INDEXED PERMIT

SEWAGE DISPOSAL SYSTEM
HOWARD COUNTY HEALTH DEPARTMENT
BUREAU OF ENVIRONMENTAL HEALTH
410-313-2640

SUBDIVISION Spring Hollow LOT NUMBER 7 ADDRESS 17125 Spring Hollow Court

Approved Septic System Plan
Howard County Health Department

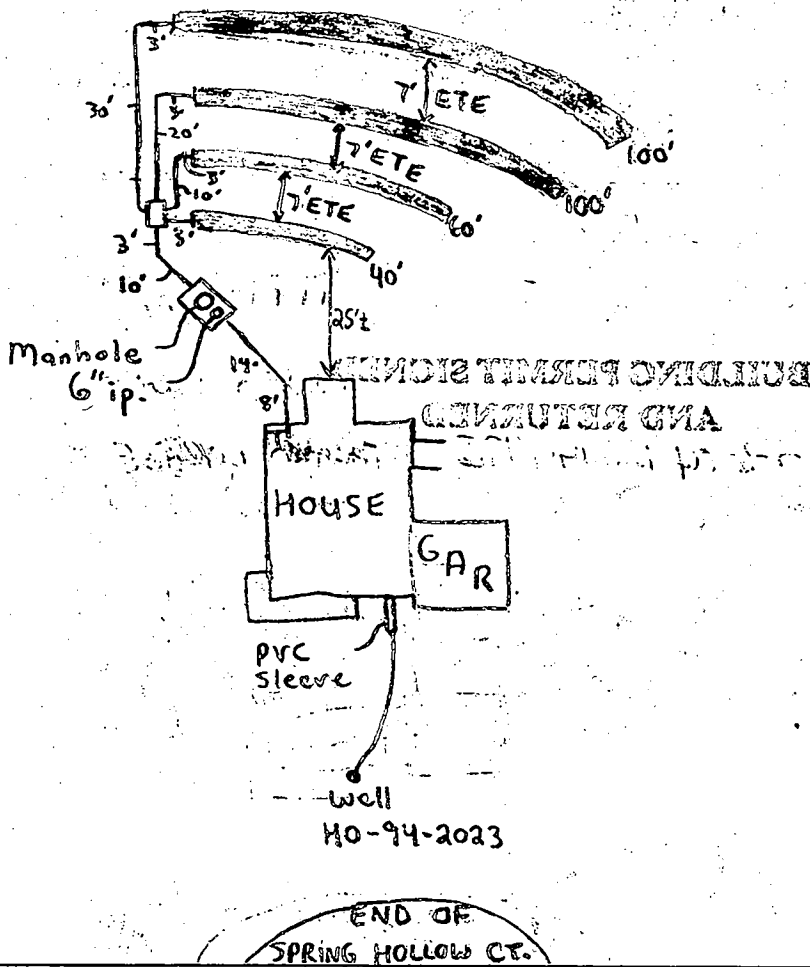
3 SYSTEMS FIT IN AREA
HEALTH DEPT. ACCEPTS THIS
MODIFICATION TO THE PLATTED

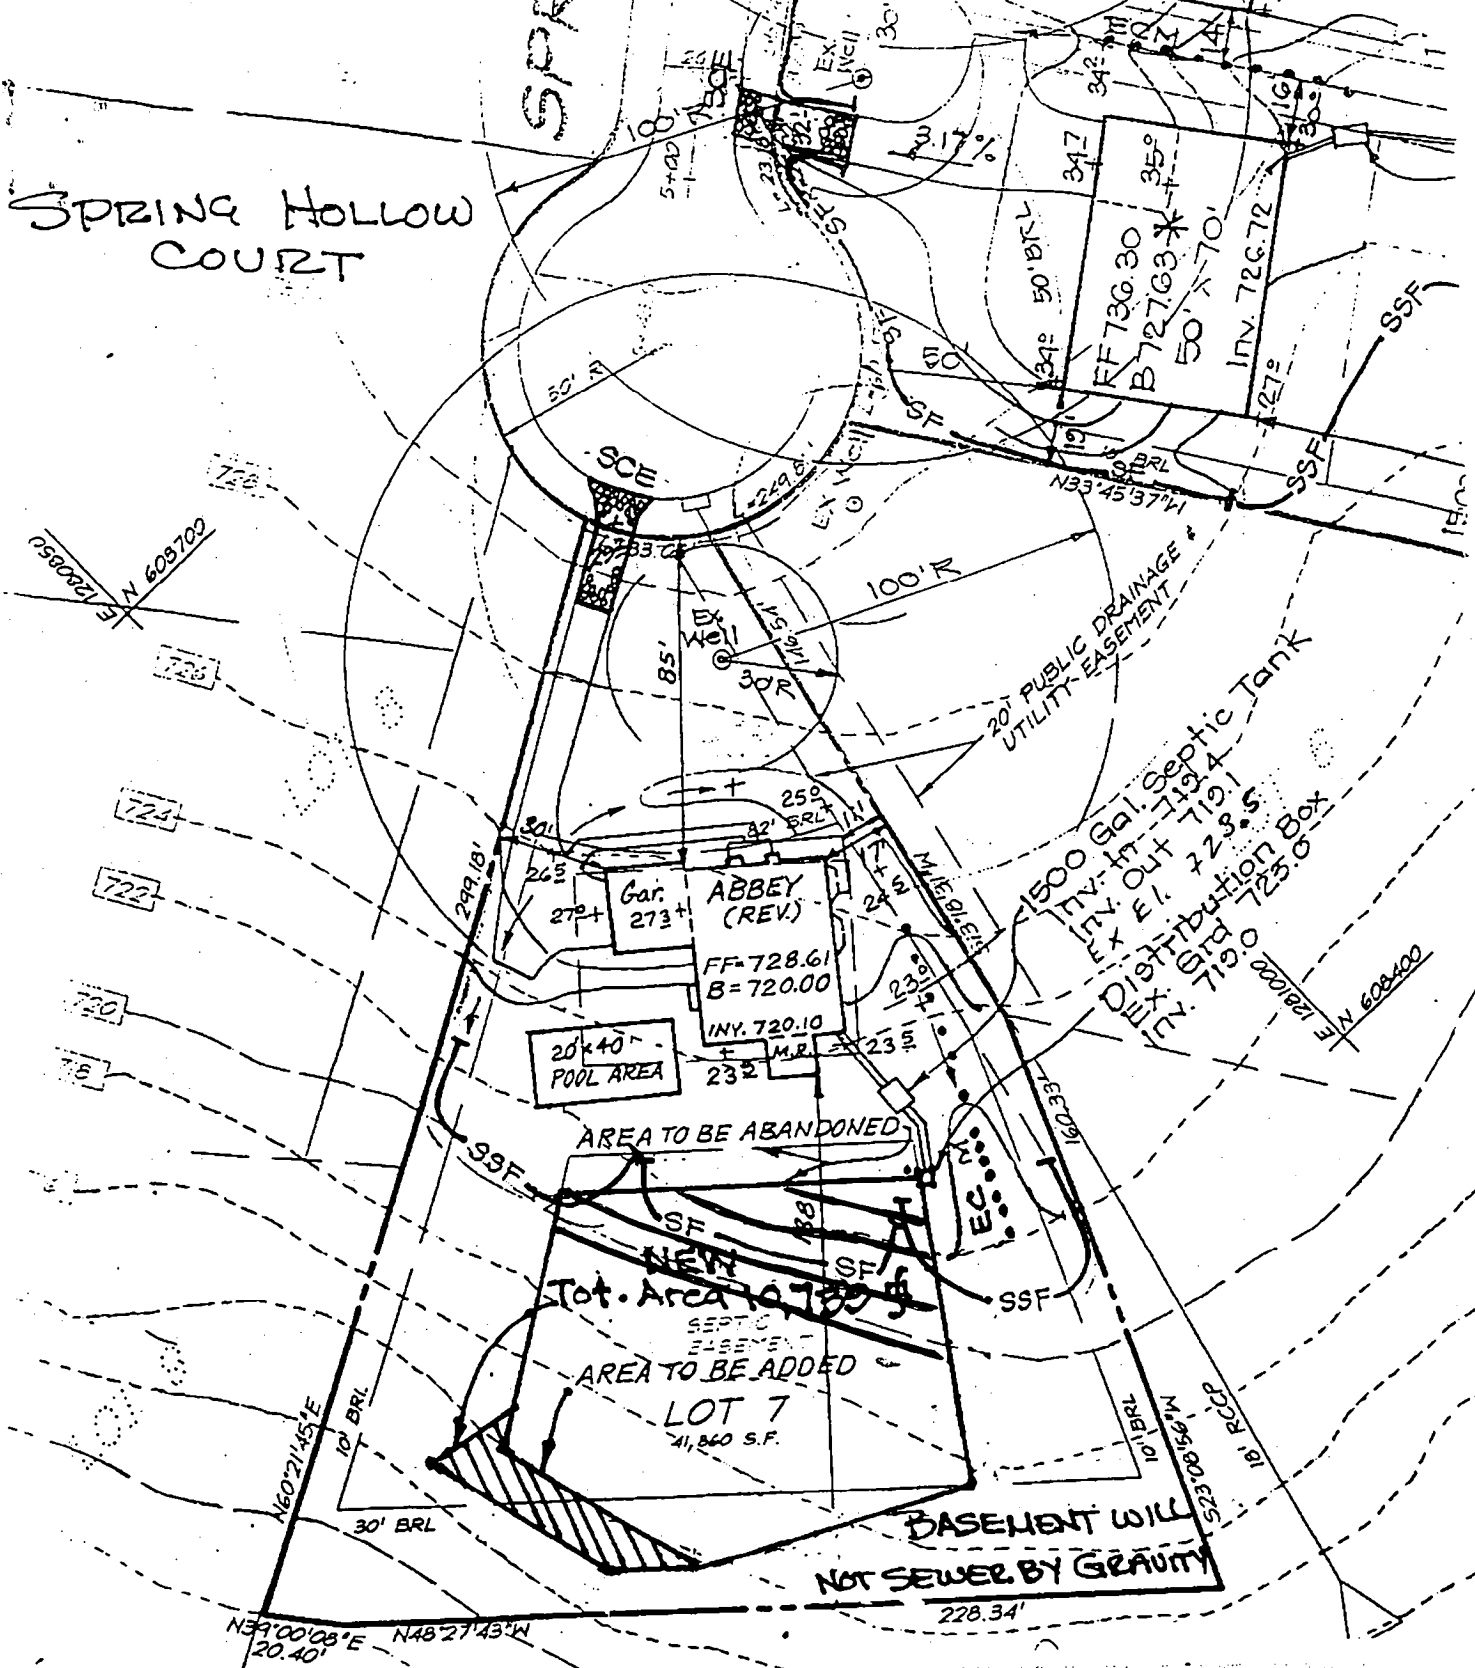
INSPECTION COMMENTS: 5/19/00-OK TO COVER FROM HOUSE TO TANK, TANK DBOX & 1ST 3 TRENCHES, RAINING FAIRLY HARD DURING SOME OF INSTALLATION. INSTRUCTED INSTALLER TO TRY TO KEEP STONE CLEAN WHEN PLACING IT IN TRENCHES, LAST TRENCH TO BE COMPLETED AT LATER DATE (SRK)
5/22/00-LAST TRENCH COMPLETE, OK TO COVER ALL WORK (SRK)

5/19/00-WPI OK (SRK)
